# ADDENDUM NO. 1

## 2015 - Installation of 3 Precast Concrete Bridges

Essex County, NY

May 28, 2015

DRAWING NO. **C/C-2** SHT. 17 OF 21  
 REV. 2

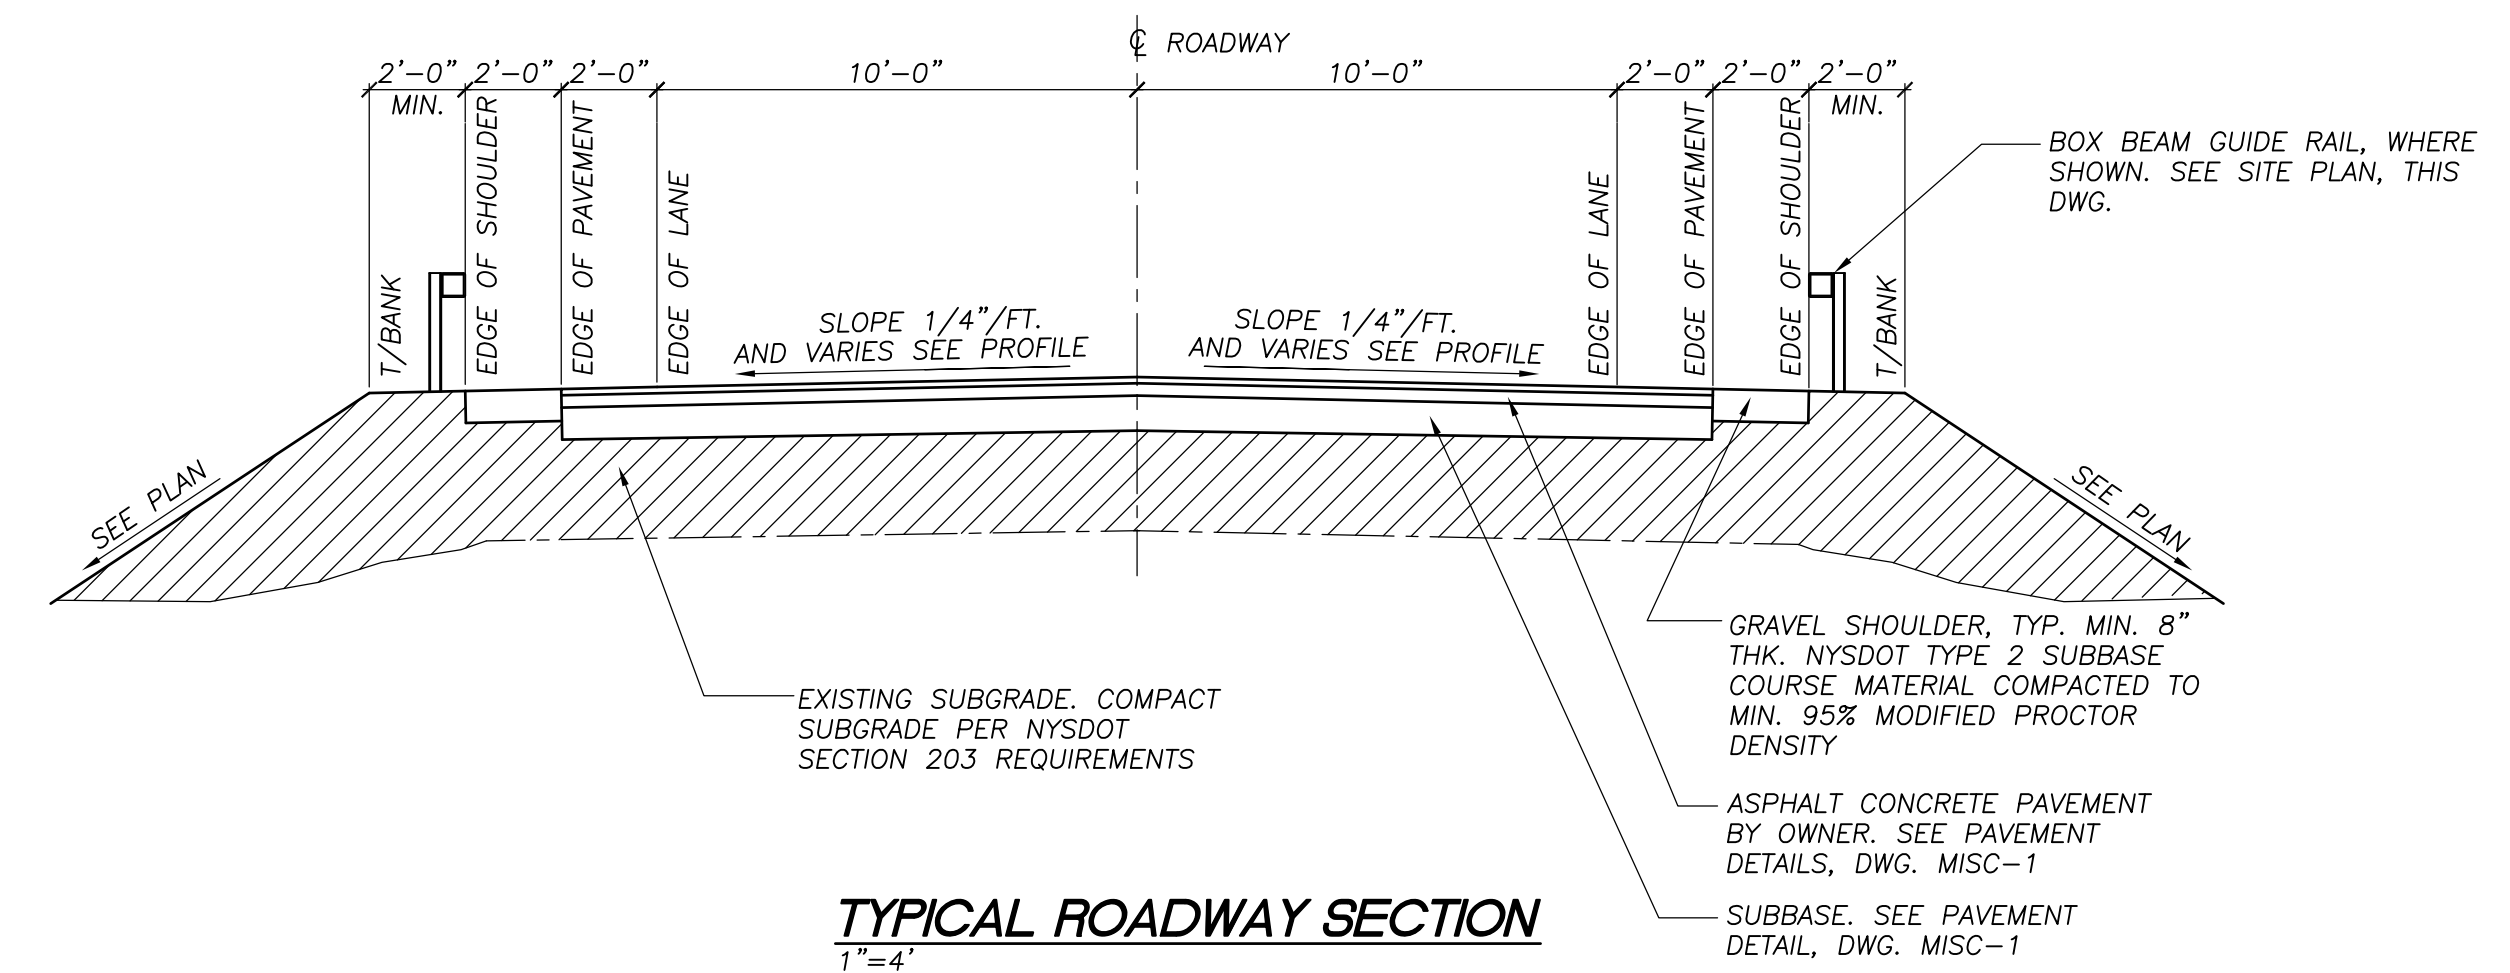
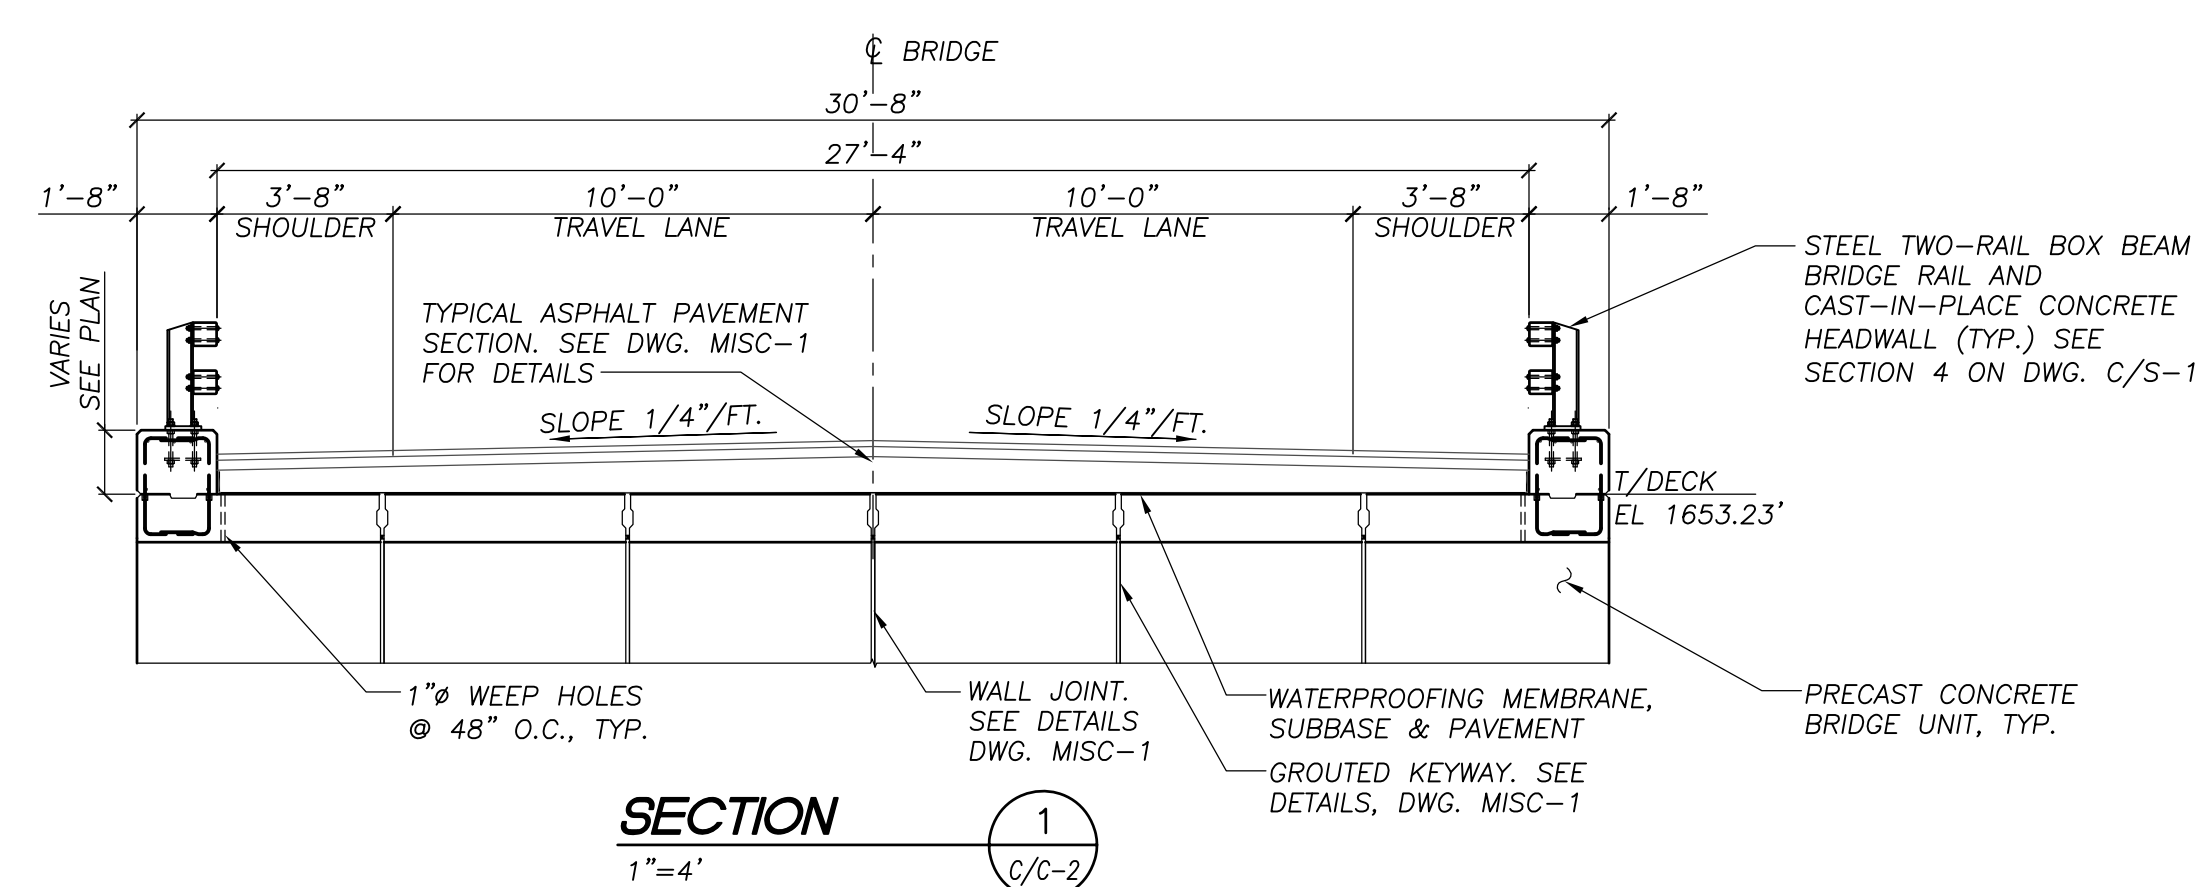
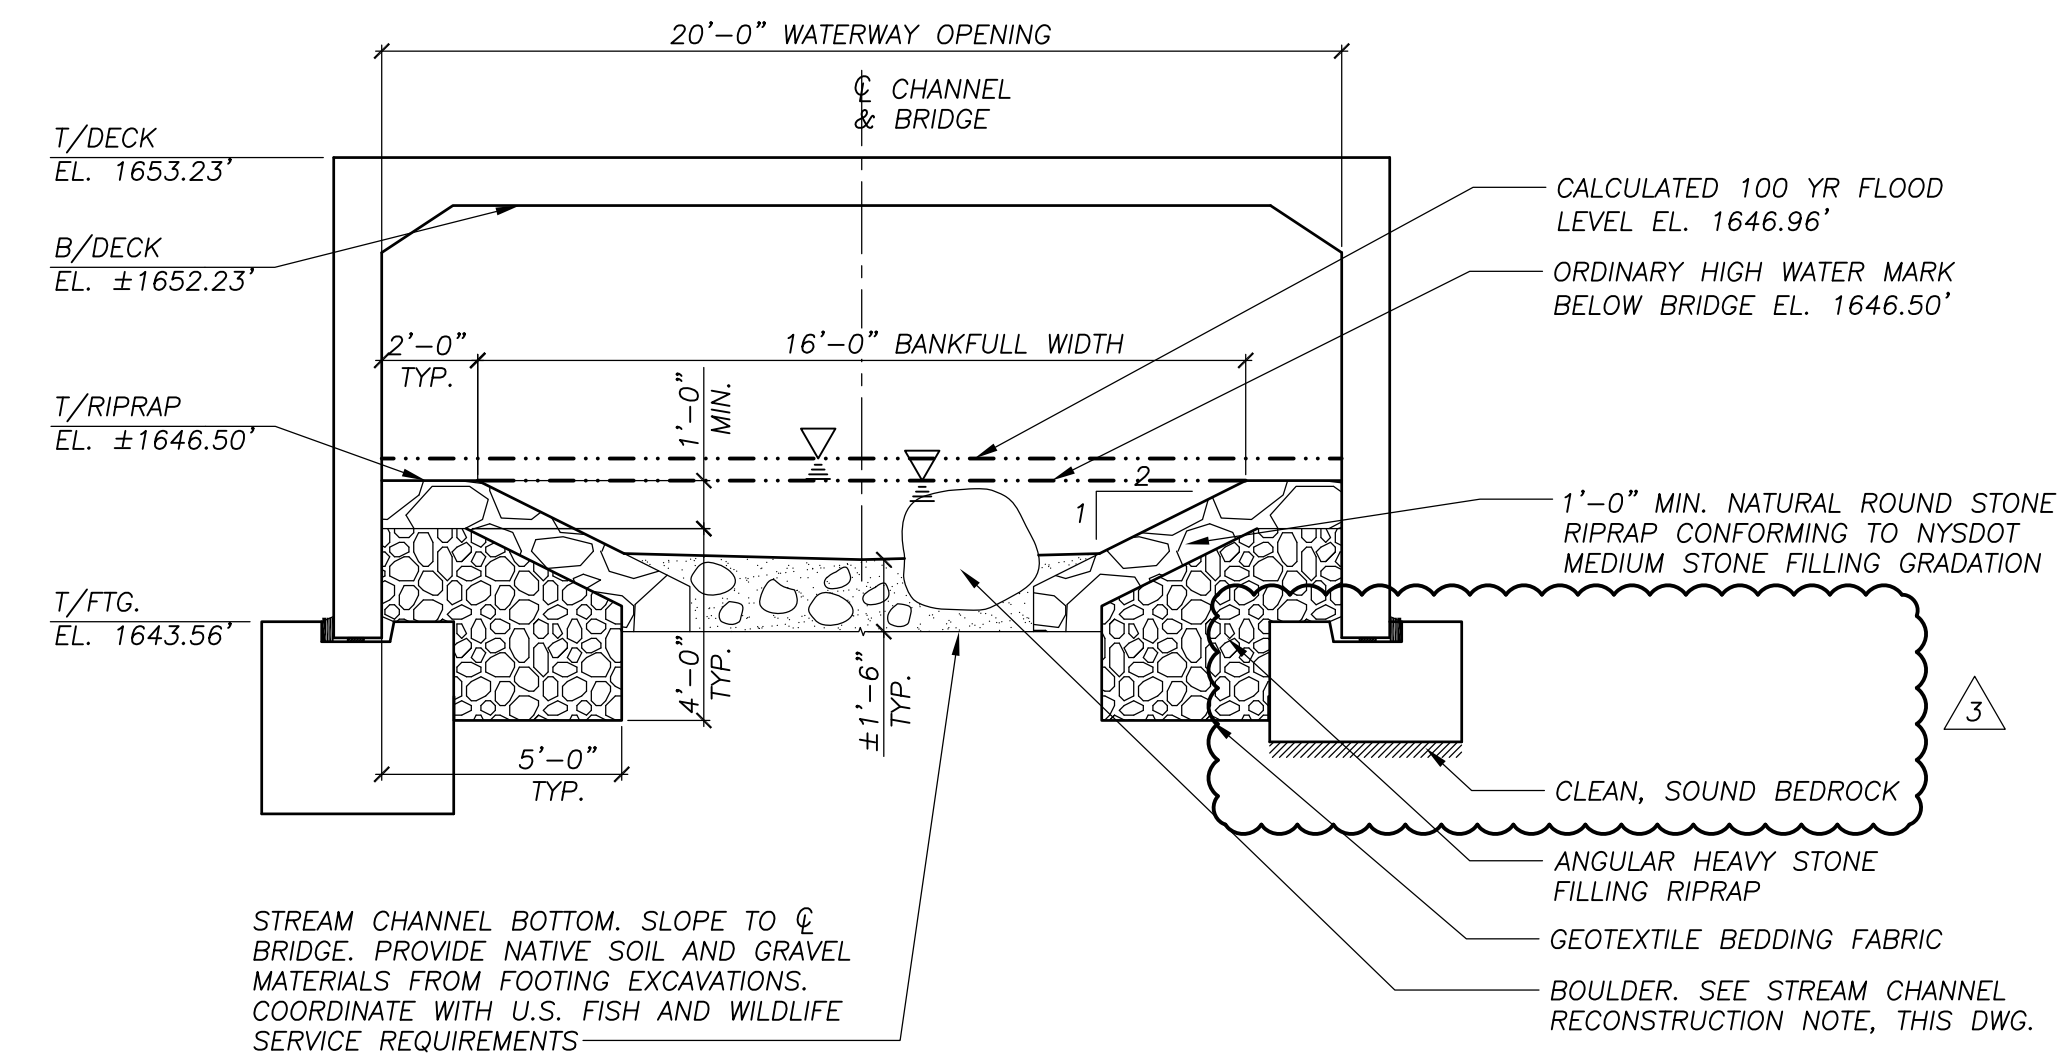
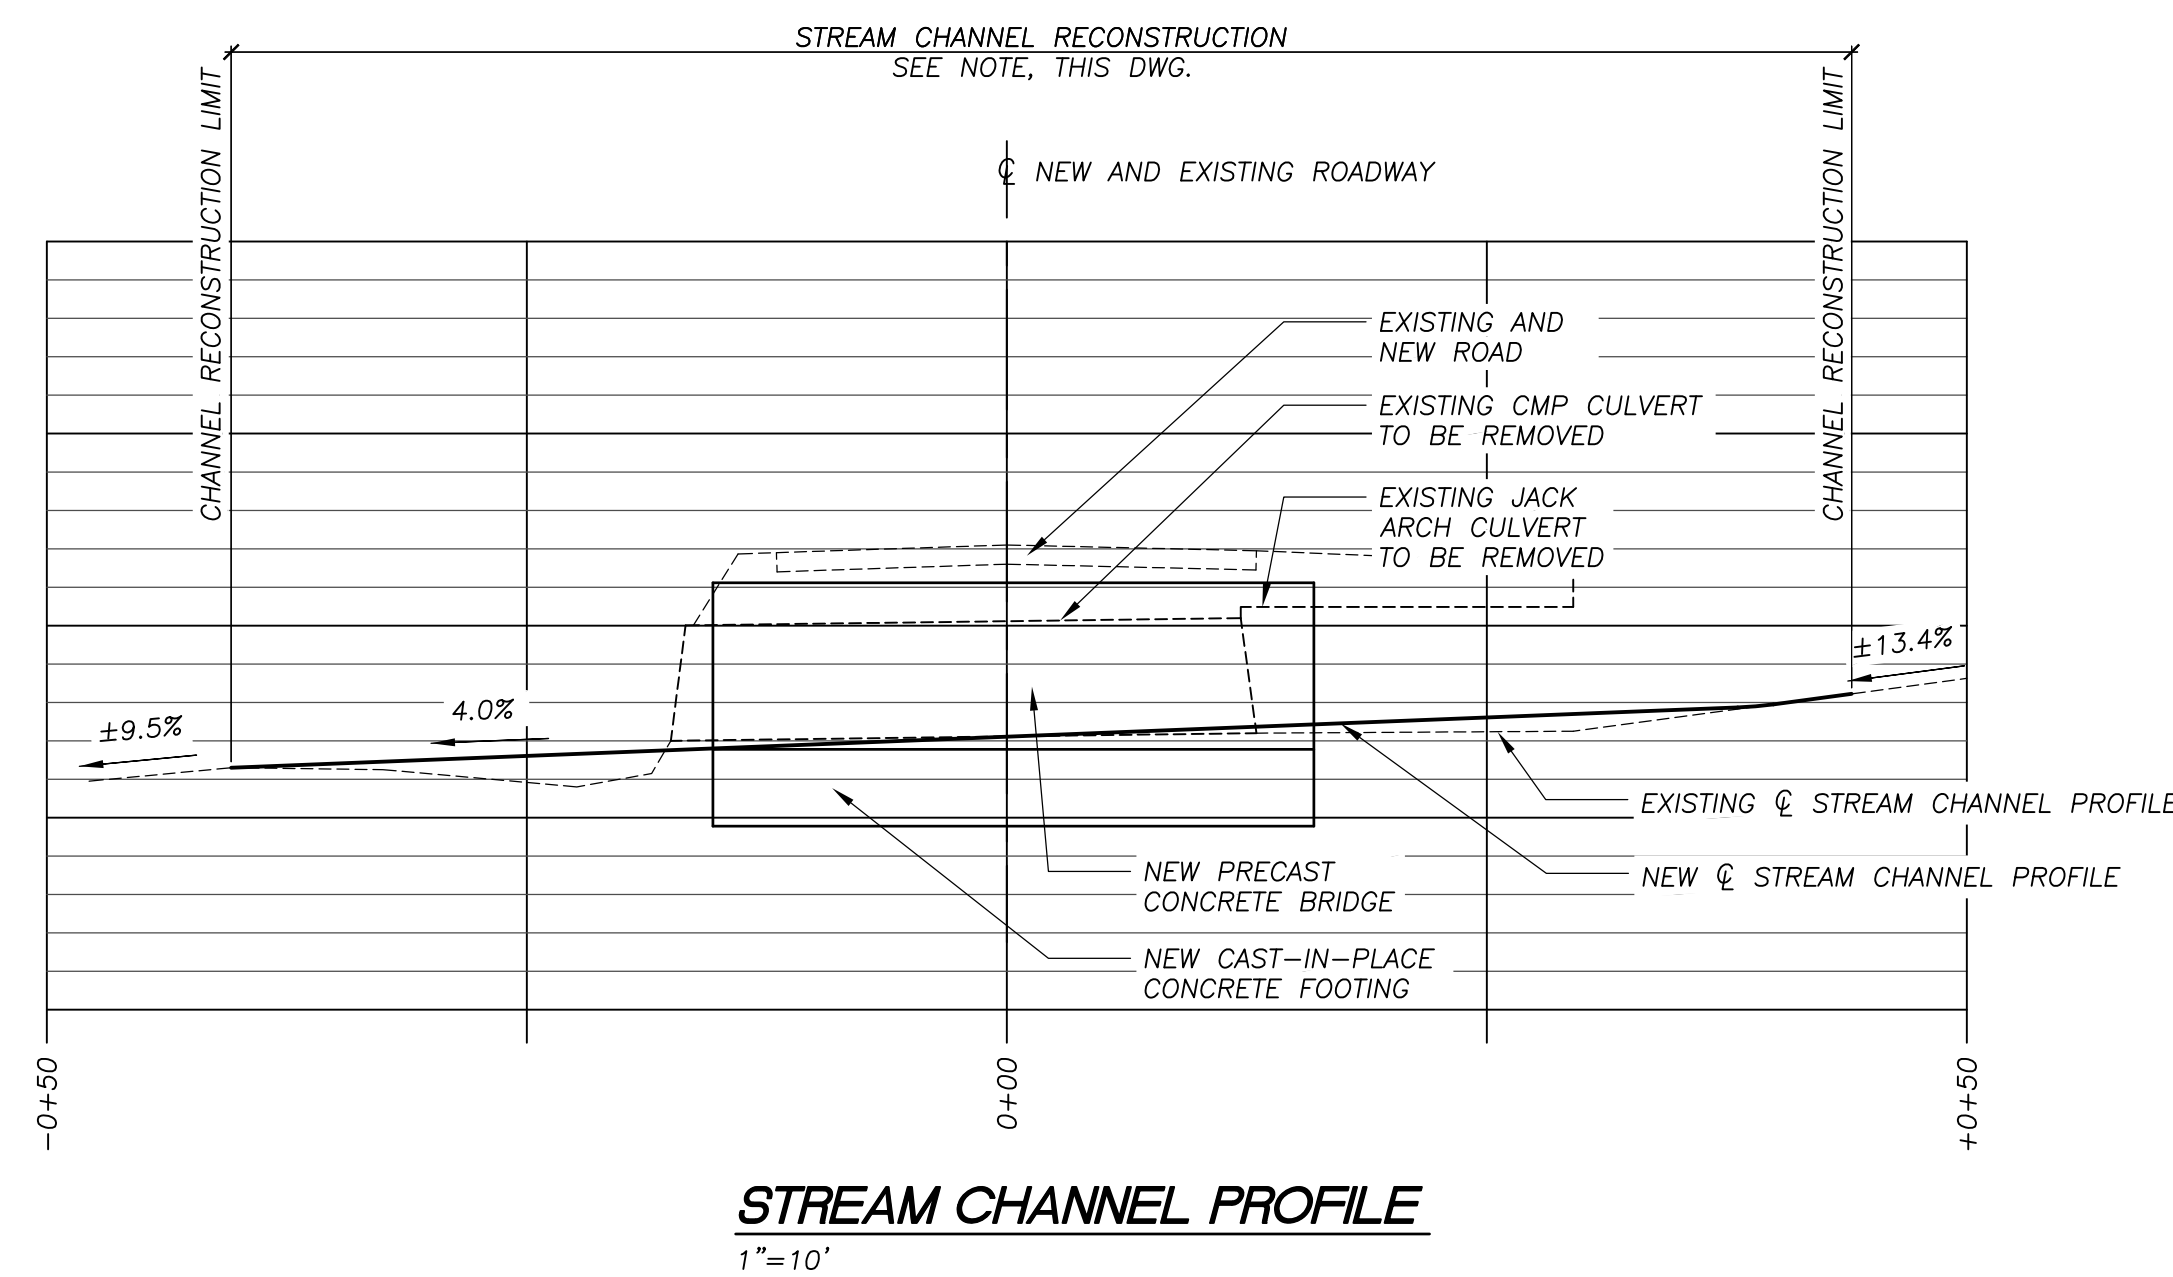
REV.	DATE	REVISIONS DESCRIPTION
0	1/19/15	ISSUED FOR REVIEW
1	2/9/15	MODS. PER TNC REVIEW
2	4/27/15	BID AND CONSTRUCTION
3	5/27/15	MODS. TO NORTH FOOTING
